## Application for Licence Amendment

<b>Licence Number</b>	L8199/2007/2
<b>Licence Holder</b>	Chichester Metals Pty Ltd
<b>ACN</b>	109 264 262
<b>File Number</b>	DER2013/001073-2
<b>Premises</b>	<p>Cloudbreak Iron Ore Mine</p> <p>Mining Tenements Mining Tenements M45/1126, M46/401, M46/404, M46/405, M46/356, M46/402, M46/410, M46/411, M46/357, M46/453, M45/1128, M46/449, M46/452, M46/451, M46/454, M46/450, M45/1084, M45/1140, M45/1139, M45/1102, M45/1105, M45/1124, M45/1103, M45/1106, M45/1125, M45/1104, M45/1107, M45/1082, 45/1083, M45/1127, M45/1138, M45/1263, M45/1303, M46/403, M46/406, M46/407, M46/408, M46/409, M46/412, M46/413, M46/414, L46/46, L46/47, L46/48, L46/49, L46/51, L46/52, L46/57, L46/62, L46/64, L46/96 L46/99, L46/130, L45/152 and Exploration Leases E45/2498, E46/590, E46/612, E45/2499, E45/2652, E45/2497, E45/6960</p> <p>MULGA DOWNS WA 6751</p> <p>As defined by Figure 1 in Schedule 1 of the Revised Licence</p>

<b>Date of Report</b>	26 August 2024
<b>Decision</b>	Revised licence granted

Figure 2: Cloudbreak mine abstraction and reinjection infrastructure  
 L8199/2007/2

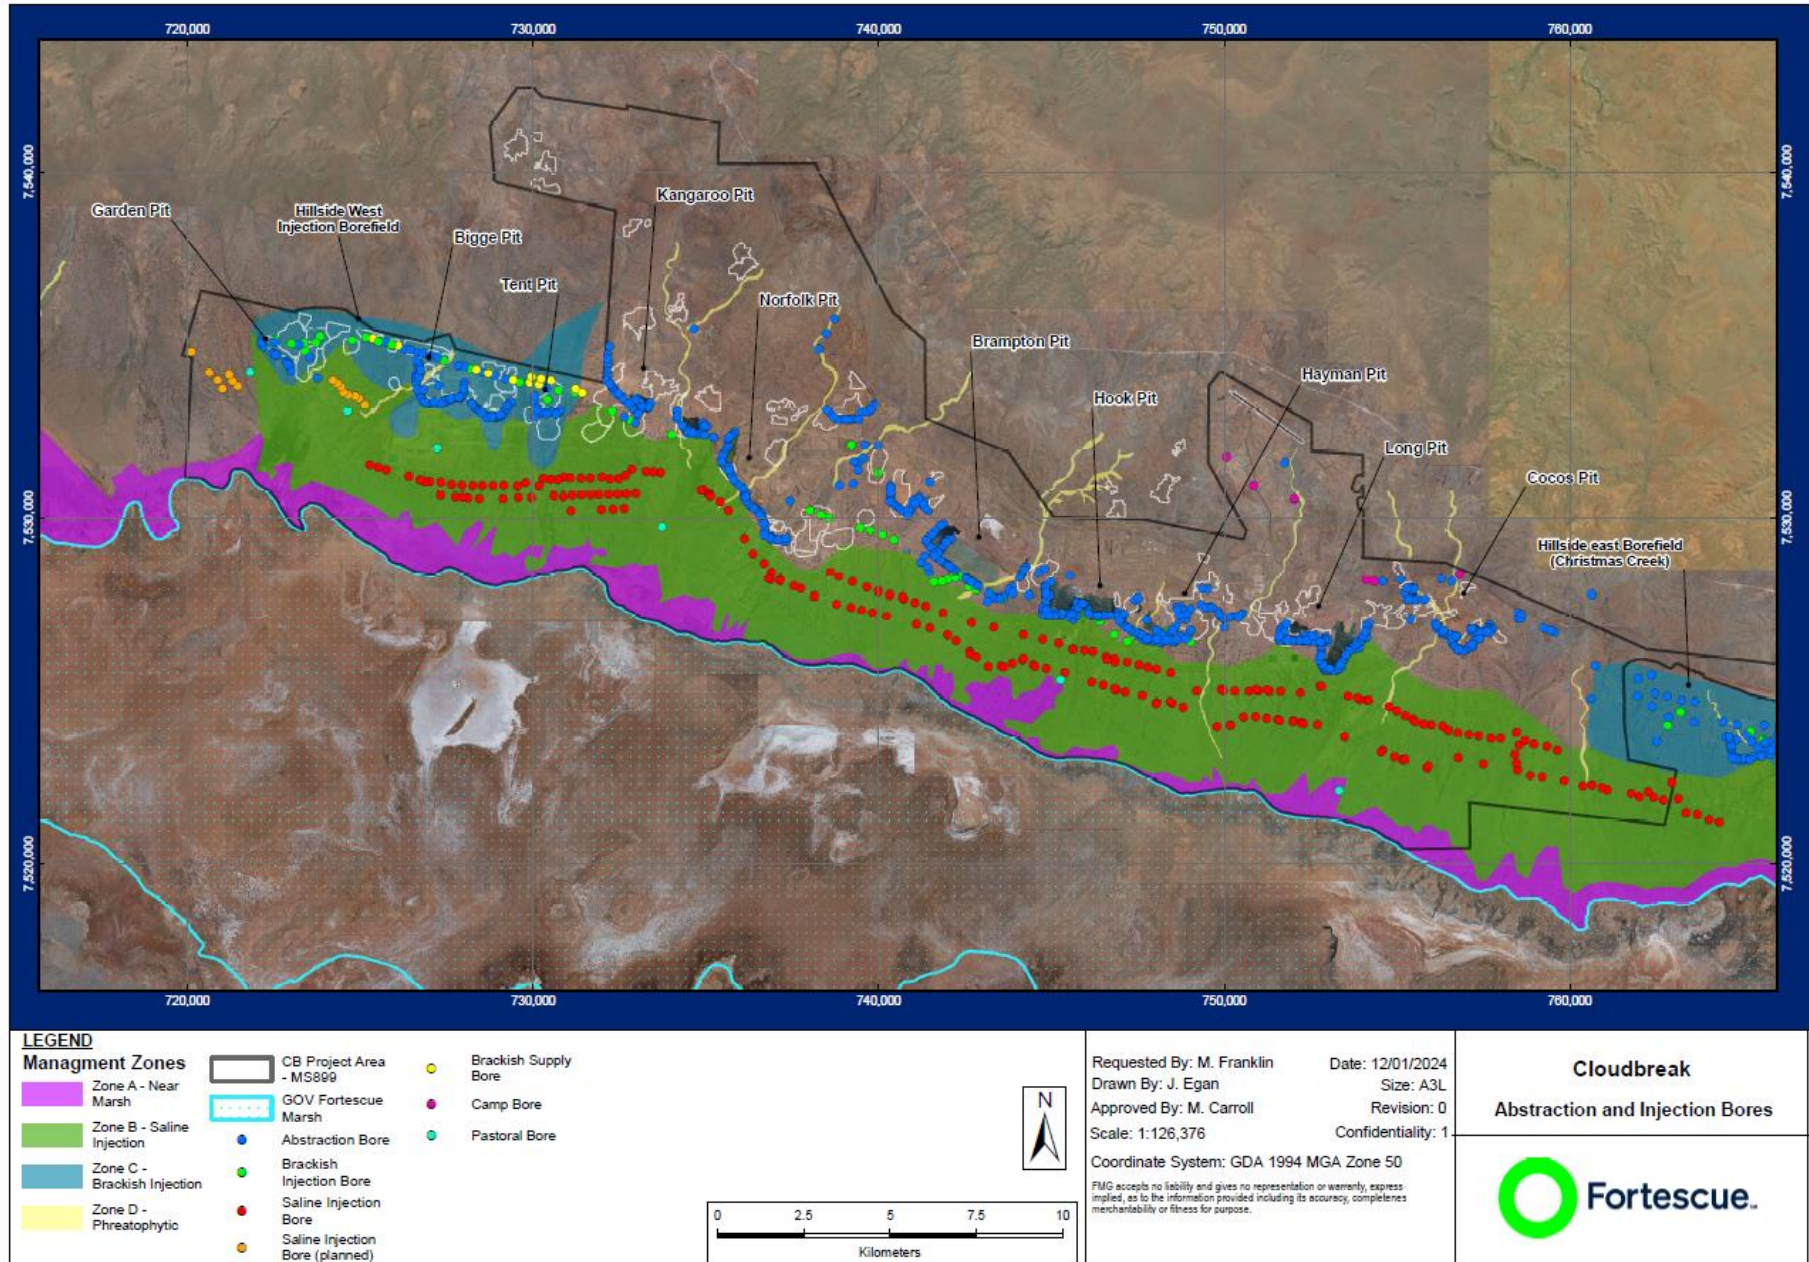
The department queried whether the current infrastructure was sufficient to support reinjection without pressurisation of the Oakover aquifer. Fortescue replied that abstracted and reinjected water is dynamically managed to ensure groundwater levels are maintained at the northern fringe of the Fortescue Marsh, consistent with the approval granted by the EPA through a Section 45C on 9 February 2024.
